The National Construction Code Volume One

SSDA Submission

The Children's Hospital at Westmead  
Paediatric Services Building

Health  
Infrastructure

Figure No. 2 – Required separation of PBS from existing adjoining Hospital Buildings on Levels 02 & 03

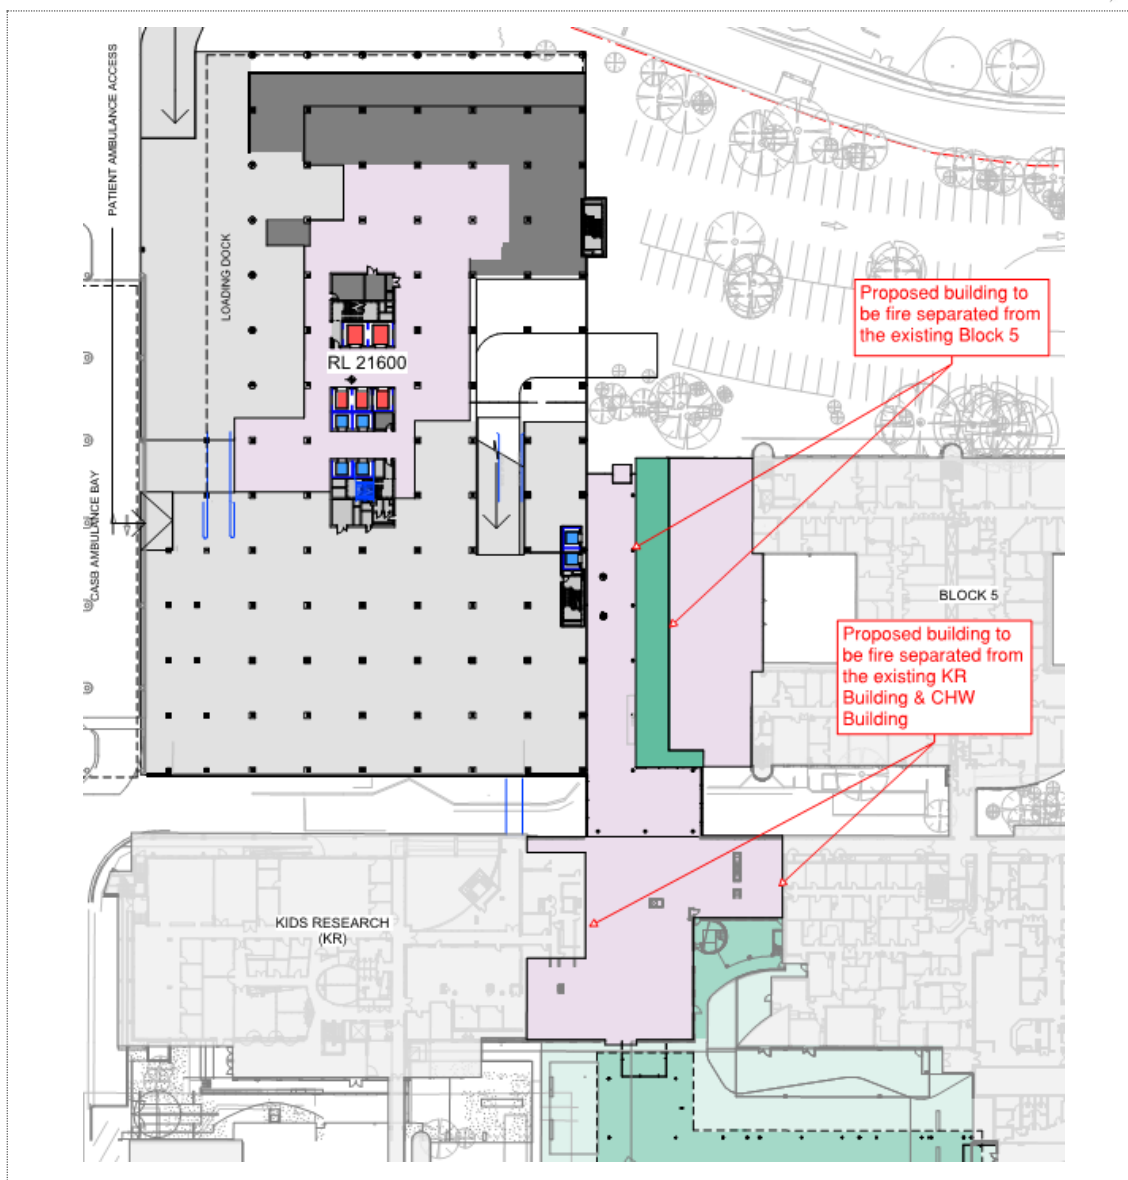
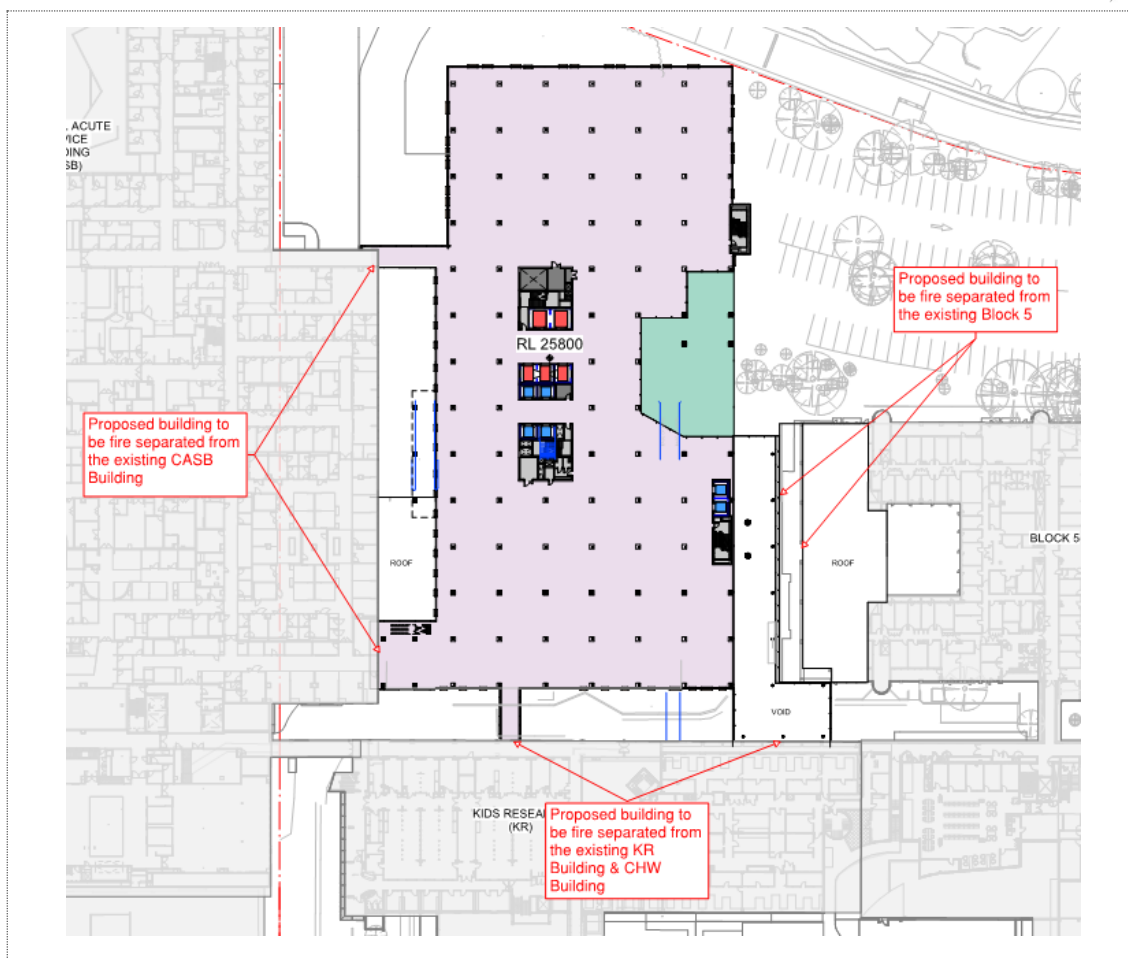
### Separation of PSB from Adjoining Hospital Buildings

The new PSB will be required to be adequately fire and smoke separated from all existing hospital buildings that are directly connected to the PSB via enclosed linkways, walkways and Kids Way Atrium Structure. In this instance adequate fire separation will be required to be provided at the interface between the PSB and the existing CASB, KRI and Children's Hospital Buildings.

All new linkways, enclosed corridors, atrium structures will be assessed as part of the PSB and will be required to be adequately fire and smoke separated from the existing hospital buildings

Figure No. 3 – Non required non-fire isolated stairway within the Kids Atrium connecting Levels 02 & 03

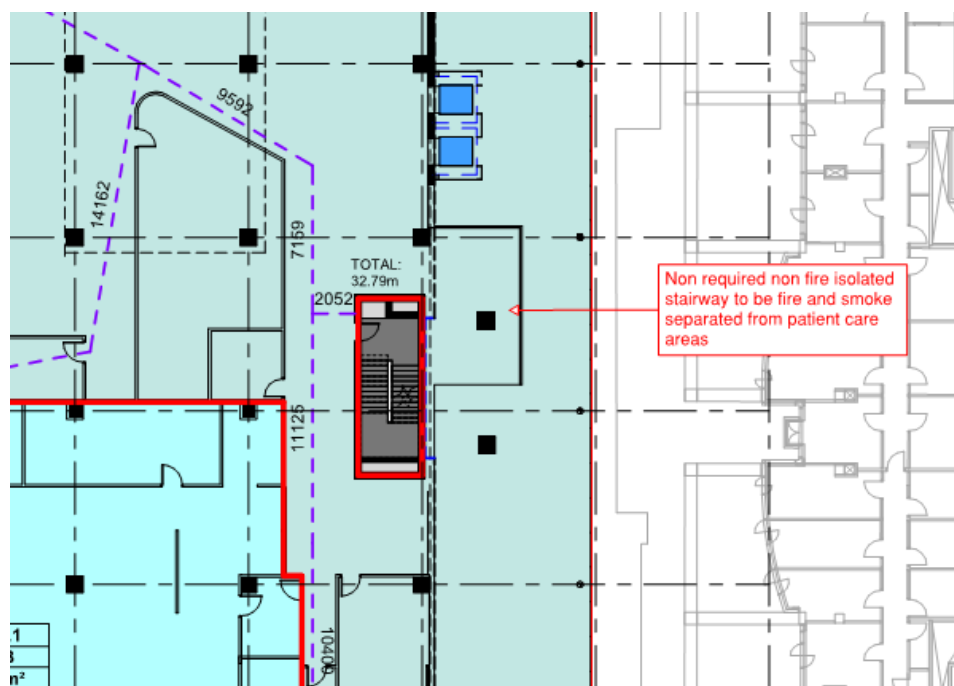
The proposed non-required non-fire isolated stairway situated within the Kids Way Atrium area which connects Levels 2 – 3 is permitted in accordance with the DtS Provisions subject to all patient care areas being fire separated from the front of house area in which the open stairway directly connects.

No patient care areas can be directly connected to or open onto the front of house area without being fire separated.

The discharge of horizontal exits into the front of house area occupied by the non-required non-fire isolated stairway and void will be required to be assessed as part of the Fire Engineering Strategy developed for the building. This will be undertaken and completed as part of the s6.28 Crown Certification process following SSDA Approval.

Figure No. 4 – Indicative location of fire hydrant booster serving the proposed PSB

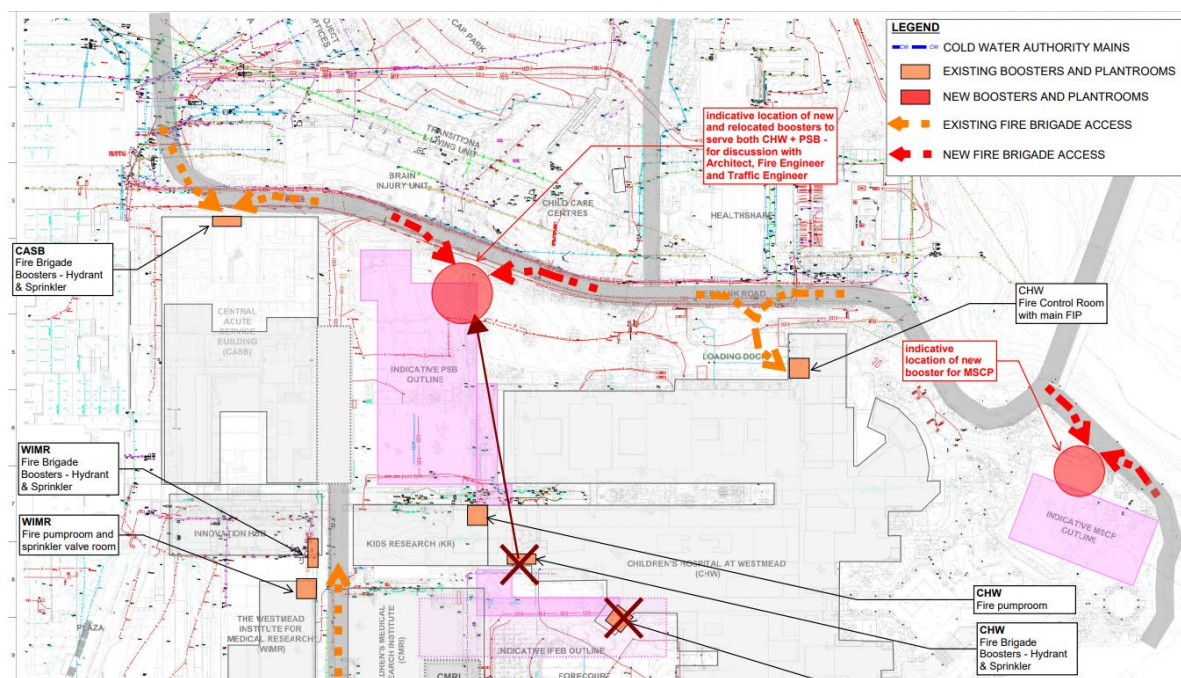
A fire hydrant booster needs to be located in a manner where it is within sight of the main entrance of the building and adjoins a primary vehicular entrance and is situated within 8m of a hardstand access to permit Brigade access.

In this regard it is noted that FRNSW access to the site is typically from either Redbank Road to the rear of the proposed development or via the main entry off Hawkesbury Road. A new fire hydrant booster will be required to be provided for the PSB. We note that the site has an existing booster and fire control centre (located from the Hawkesbury Road side) which will likely be re-positioned as part of the proposed works to align with the proposed booster location due to the fact that the main entry / access will be impacted by the new KIDSPARK forecourt which will prevent access to the existing booster.

The proposal for a rear booster position does align with the recently completed Central Acute Services Building (CASB) located adjacent to the proposed PSB.

The location of the booster in terms of proximity and sight to the main entrance of the building will be required to be assessed as part of the Fire Engineering Assessment to be undertaken by Mott MacDonald in order to demonstrate compliance with the nominated Performance Requirements of the BCA. This will be undertaken and completed as part of the s6.28 Crown Certification process following SSDA Approval.
